<i>NCSX RFD</i> <i>Part I</i>	Number: 14-020	RFD Description: Type A1 MCWF Flange Hole Modifications
Initiator: Mike Griffith		Organization: Major Tool
List of Impacted Documents: <i>(Specification, MIT/QA Plan, SOW, drawing, etc.):</i> SE141-114		
Cost Impact: <i>(If none, so state):</i> NONE		
Schedule Impact: <i>(If none, so state):</i> NONE		
Quality Impact: <i>(If none, so state):</i> NONE		
State Requirement Deviation is Requested For: <i>(Specification, MIT/QA Plan, SOW, drawing, etc.):</i> SE141-114		
Full Description of the Deviation Requested: <i>(Use continuation pages, e-mails, letter, sketches, etc. as needed and include amplifying information as appropriate to support deviation request.):</i> Major Tool noted casting interference at the bolt locations shown in the attached figures for the Type A MCWFs (See Attachment 1). RFD-14-018 addressed the resolution for the Type A2 through A6 MCWFs. This casting interference is similar to what was noted on the type C winding forms, but more severe in these areas. After some discussion (teleconference the evening of March 29th), it was decided that this interference condition will be accepted “as is” for these locations on the A

Attachment (1)
Type A MCWF Interferences

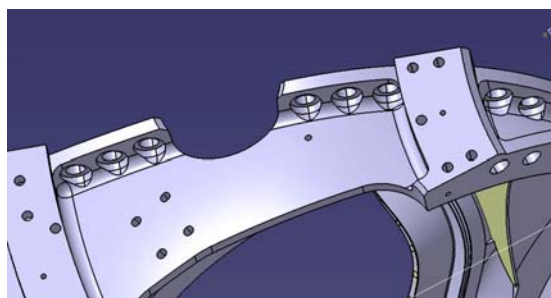
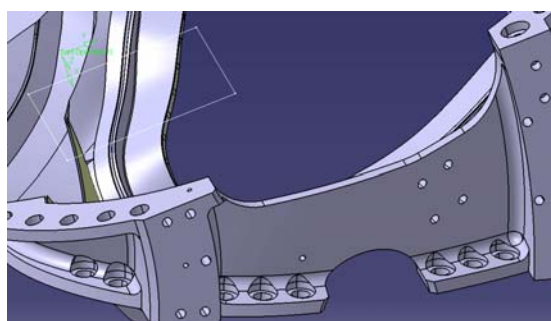
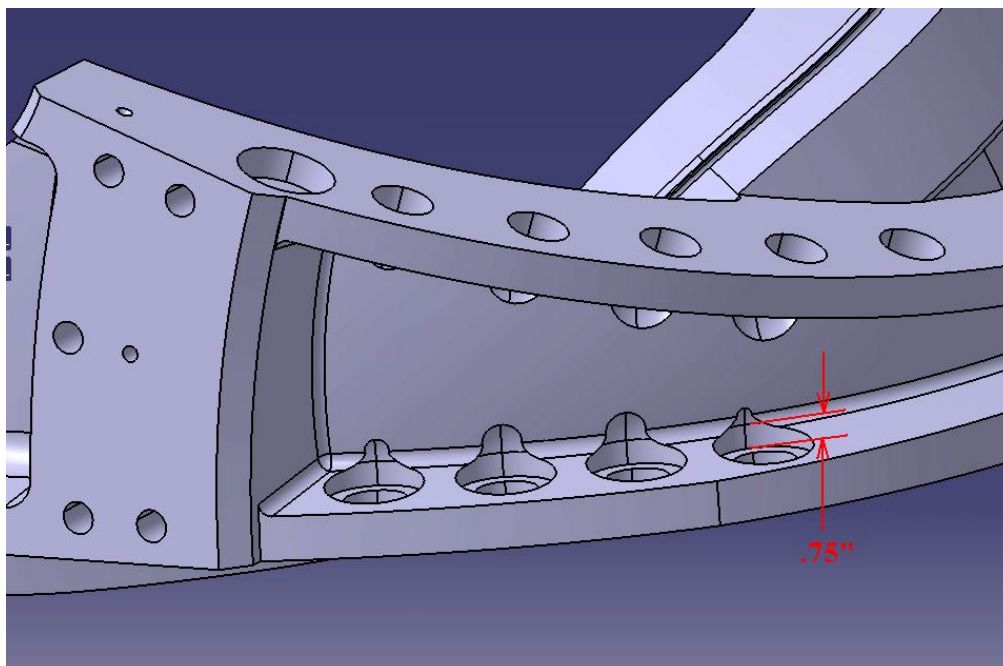
Relief area cut into cast wall

The pictures below illustrate how much casting wall interference there will be on the type A casting. The current machining models for all three winding forms have this interference problem to some degree. The models have a 3" counterbore that extends .75" from the face and the remainder of the feature is a 1.5" radius (see below). This is why Major Tool had to perform the grinding around the counterbores on C4 in order to get the 3" diameter gage to fit.

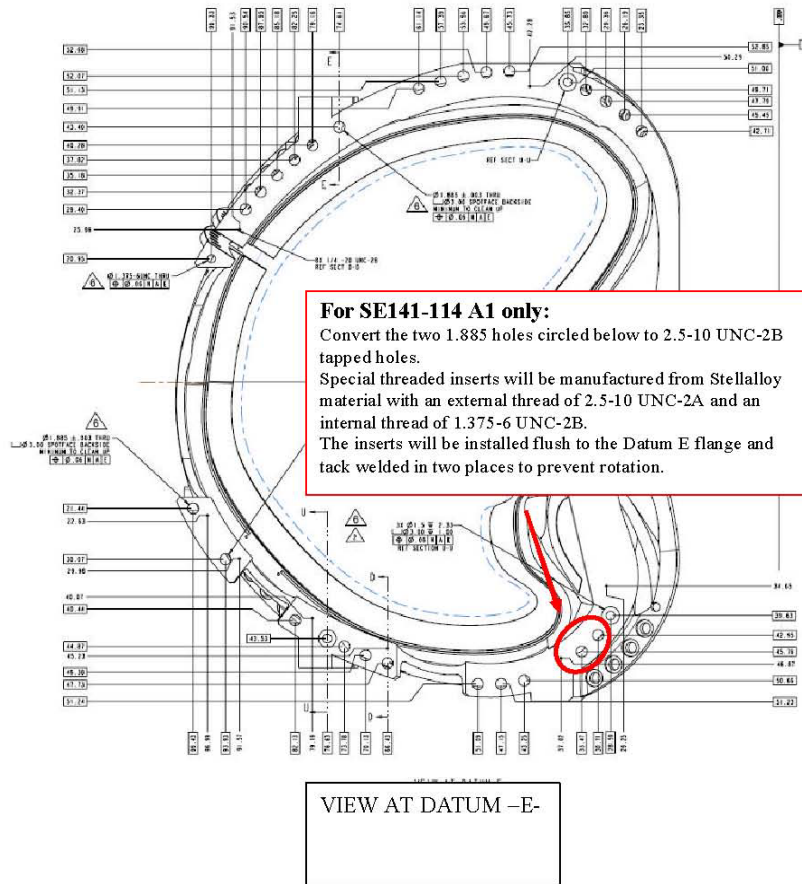
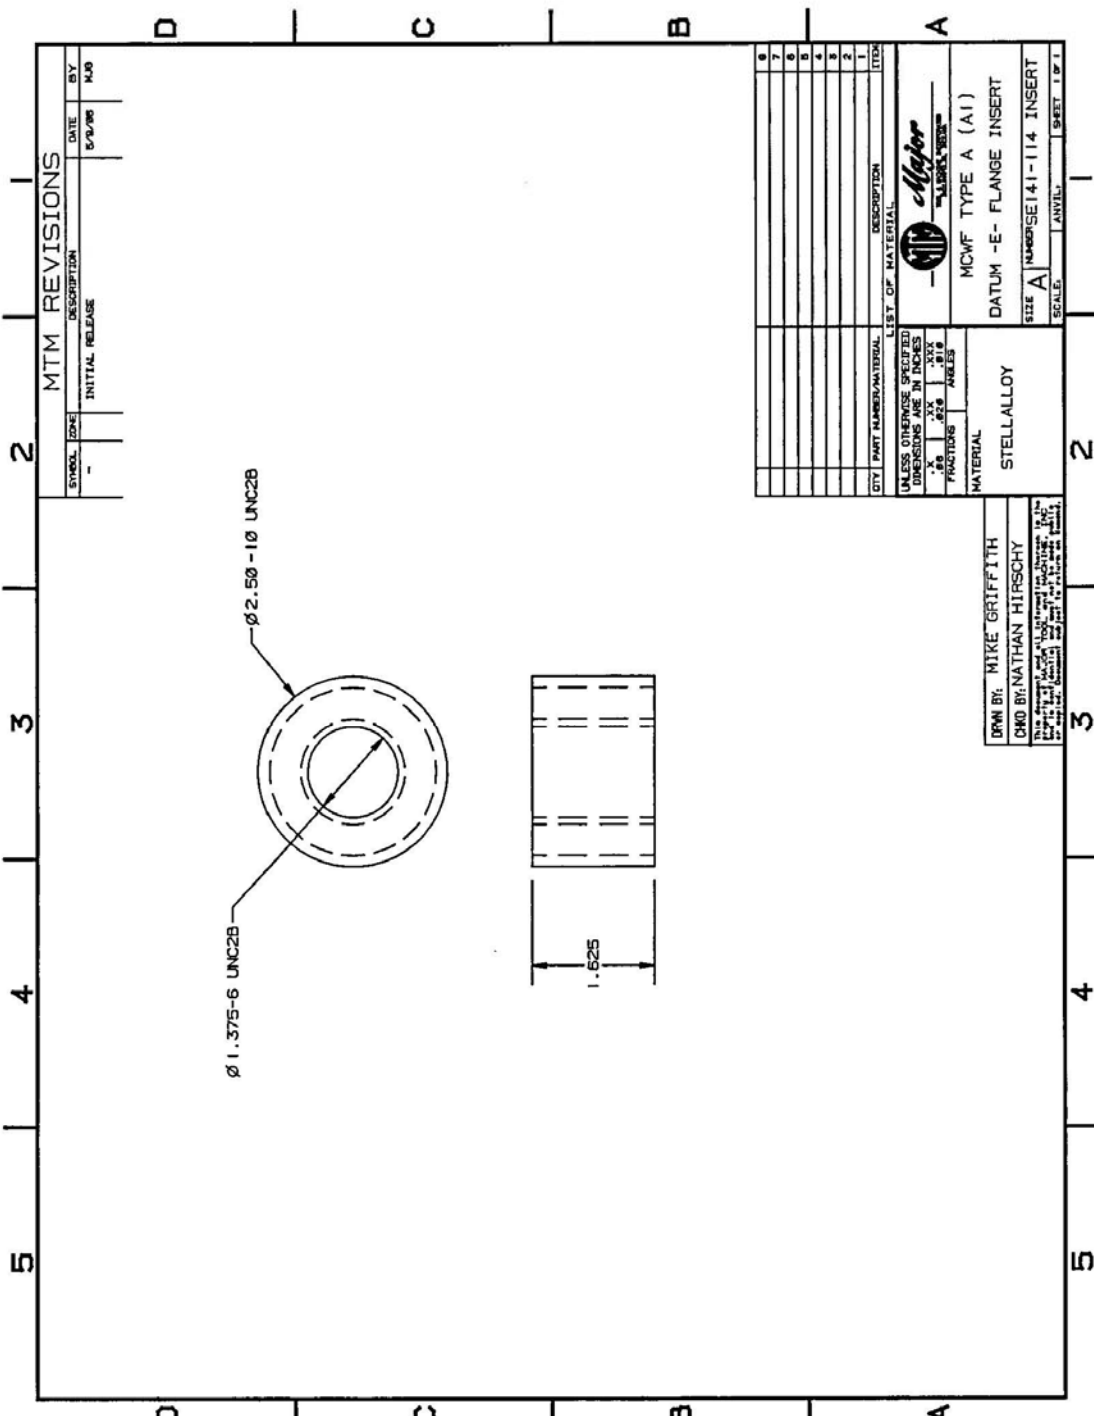
Attachment (2)
Proposed Resolution to Type A MCWFs

NCSX RFD <i>Part III</i>	Number: 14-020	RFD Description: Type A1 MCWF Flange Hole Modifications
RLM: Brad Nelson		Organization: ORNL
Impact on Interfaces with Other WBS Elements/Items: (If none, so state): NONE		
RLM Recommendation: ☒ Approve ☐ Do Not Approve Additional remarks: These modifications will be incorporated in a future revision to this drawing. In the interim that “stamp” process will be used to annotate SE141-114. Does this Change Impact Material Already Procured or Parts/Assemblies Already Assembled/Manufactured using this Material: ☒ Yes ☐ No If “Yes”, what is the recommended disposition of this material/part/assembly? A1 Casting will be accepted “as is” with the exception of the two holes shown.		
RLM Signature: _____		
Project Disposition: ☒ Approved. No ECP required. _____ NCSX Systems Engineering Support Manager ☐ Approved. ECP will be assigned and processed. ☐ Not Approved. Reason(s) for disapproval:
